Executive Order G-70-25-B

Relating to the Modification of the Certification of the
Atlantic Richfield Balance
Phase II Vapor Recovery System

ATLANTIC RICHFIELD COMPANY BALANCE PHASE II

Executive Order G-70-25-*B*
ARCO Phase II Balance
Vapor Recovery System
Component List

EXHIBIT 1

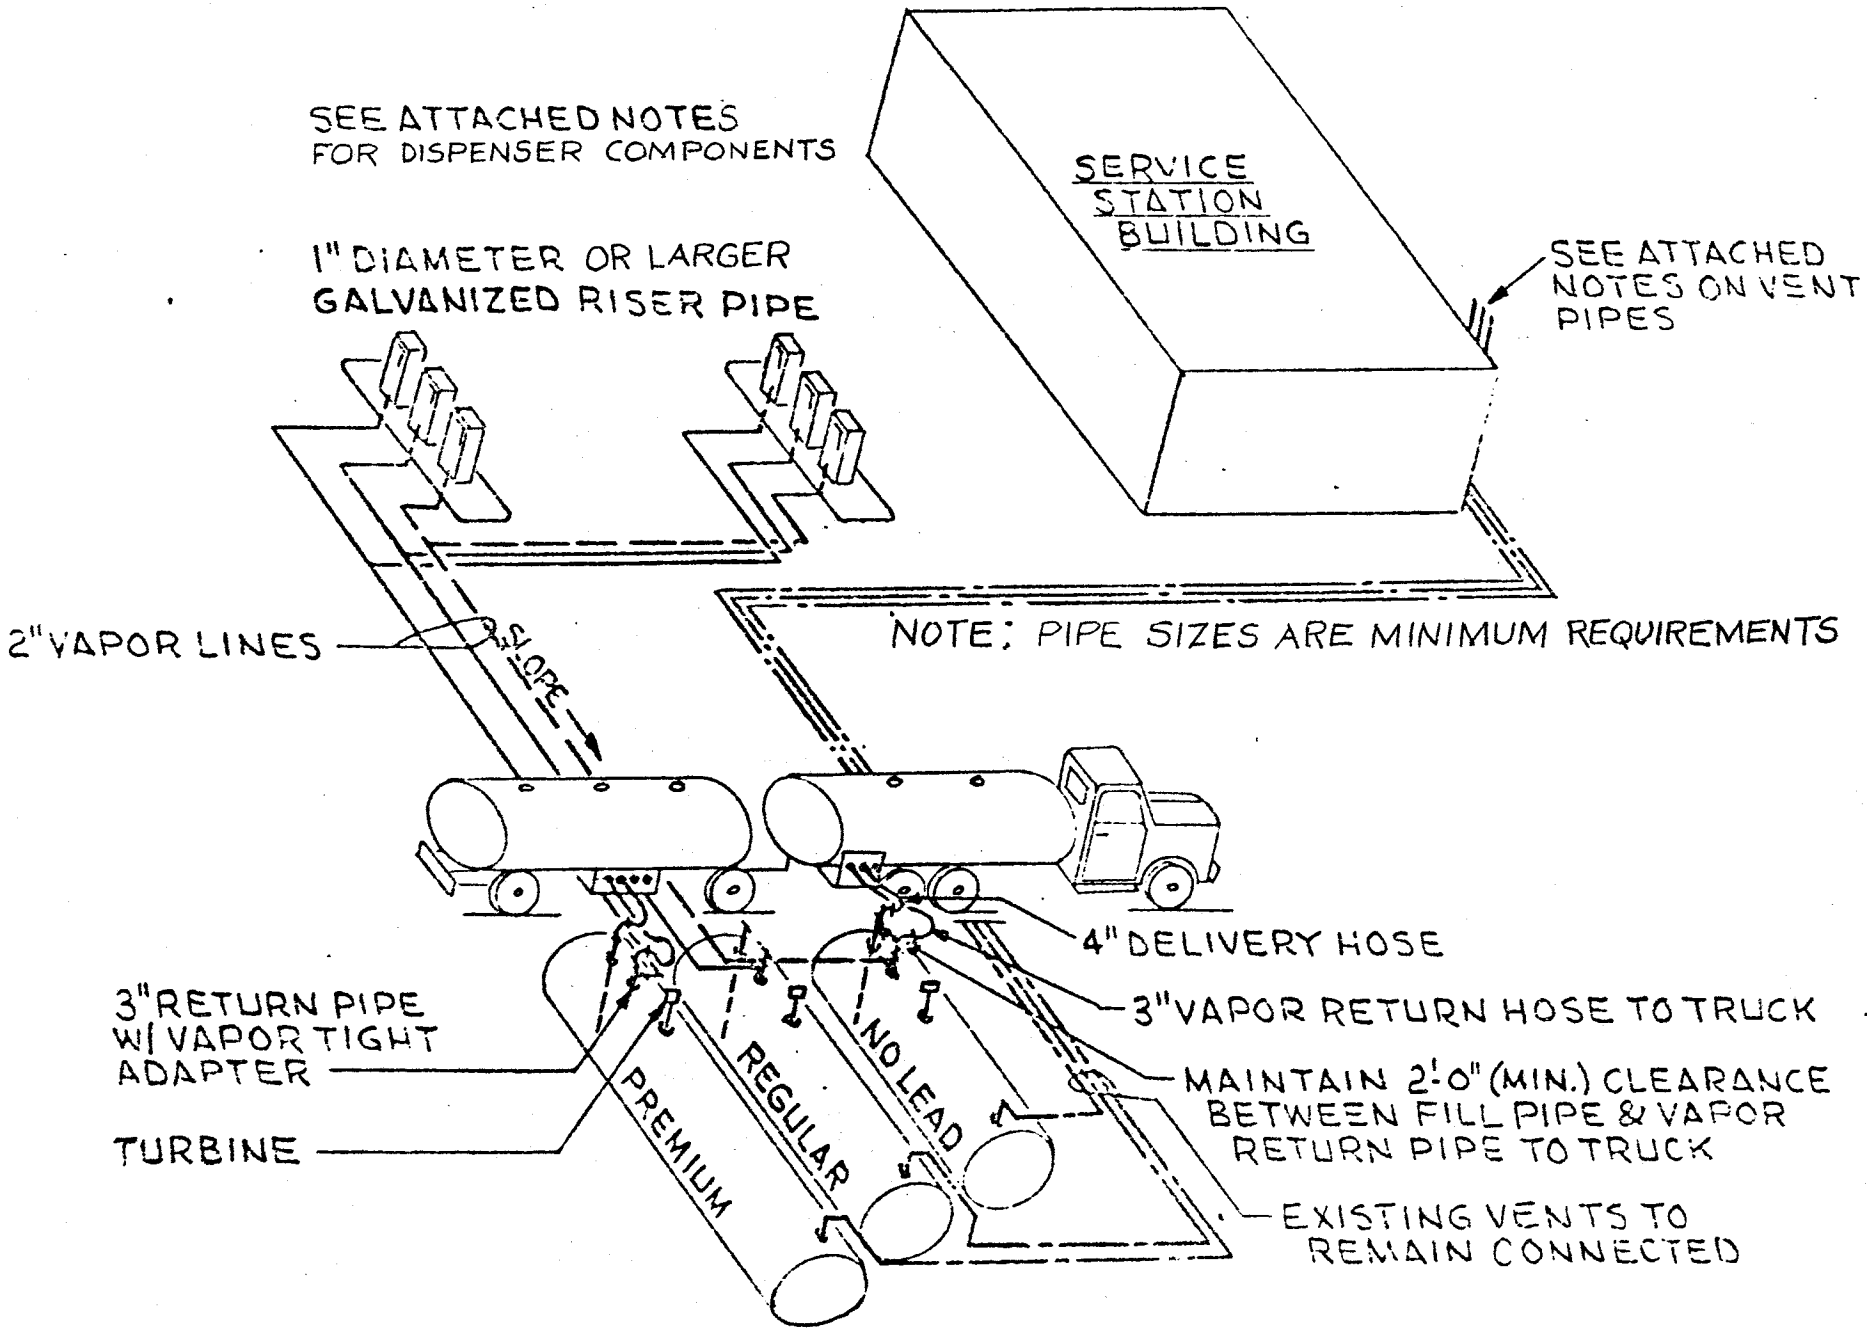
1. Require dual plane 90° swivels at the nozzle end of vapor and liquid hoses, and

2. Eliminate the previously allowed use of a single OPW 78 series recirculation trap on dual dispensers dispensing the same product from both sides.

7. State Fire Marshal approved swivels ~~(and-offsets-if-necessary)~~ for this system shall be selected and installed on hoses to prevent hose kinking.

~~10. On-dual-dispensers-dispensing-the-same-product-from-both-sides,-the-vapor return-lines-may-be-connected-to-a-single-OPW-78-series-recirculation trap.~~
